# Access Compliance Report

## Public Rights-of-Way

### (Curb Ramps)

Intersection ID: 12684	Main Street: S_BREVARD_ST	Cross Street: E_4TH_ST	Location: W
ADA ID: 24E9BF979045	Ramp Type: Perp	Initial Pass/Fail: Fail	Overall Compliance: No
Severity Score: 22.5			
Codes/Mitigation Info/Possible Solution		Field Measurements/Component Compliance

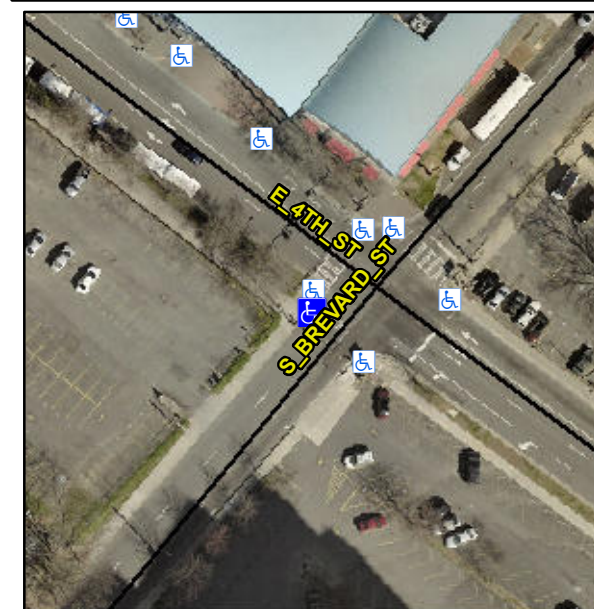
**Not Found, R304.5.1, R304.2.2**

Compliance	Description	Data	Compliance	Description	Data
N/A	Ramp Length (in)	62.0	No	Ramp Slope (%)	9.1
No	Ramp Width (in)	46.0	Yes	Ramp XSlope (%)	2.8
N/A	Flare Type LT	N/A	N/A	Flare Type RT	N/A
N/A	Flare Slope LT (%)	N/A	N/A	Flare Slope RT (%)	N/A
N/A	Flare Traversable LT?	N/A	N/A	Flare Traversable RT?	N/A
N/A	Landing Length (in)	N/A	N/A	DWS Provided?	N/A
N/A	Landing Width (in)	N/A	N/A	DWS Contrast?	N/A
N/A	Landing Slope (%)	N/A	N/A	DWS Length (in)	N/A
N/A	Landing X Slope (%)	N/A	N/A	DWS Full Width?	N/A
N/A	Landing Curb? (Y/N)	N/A	N/A	DWS Offset (in)	N/A
N/A	Shared Landing?	N/A			
N/A	Gutter Ponding?	N/A	N/A	Gutter Slope (%)	N/A
N/A	Gutter Lip Ht (in)	N/A	N/A	Gutter X Slope (%)	N/A
N/A	Painted X Walk1?	Yes	N/A	Painted X Walk2?	N/A
	X Walk 1 Direction	To SE		X Walk 2 Direction	N/A
N/A	X Walk 1 Width (in)	106.0	N/A	X Walk 2 Width (in)	N/A
	X Walk 1 Slope (%)	0.2		X Walk 2 Slope (%)	N/A
	X Walk 1 X Slope (%)	3.0		X Walk 2 X Slope (%)	N/A

**Remove & Replace Entire Ramp.**
